# Service Bulletin

Bulletin No.: PI0998B

**Subject:** Accessory Tri-Fold Tonneau Cover Prevents Endgate/Tailgate from Closing

**Models:** 2014 Chevrolet Silverado 1500  
2014 GMC Sierra 1500

3461386

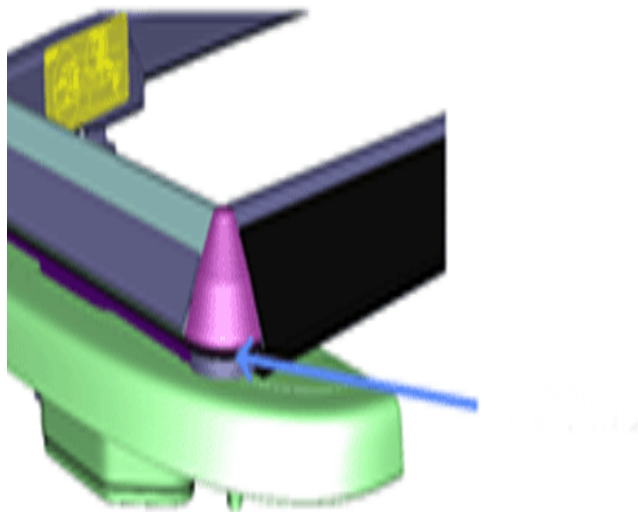
Some customers may comment that the tailgate will not close with the tri-fold tonneau cover in the closed position. This may be due to an early production condition caused by excessive twist in the rear rail of the tonneau cover, and the tailgate molding is not positioned flat on top of the tailgate.

Improve the clearance from the rear rail to tailgate by conducting the following steps below.

2. Remove the adhesive liner from the pad and attach to the rear current corner pads on the right and left side as shown in the illustration above.

**Note:** If additional clearance is required, add a second layer of corner pads to each side.
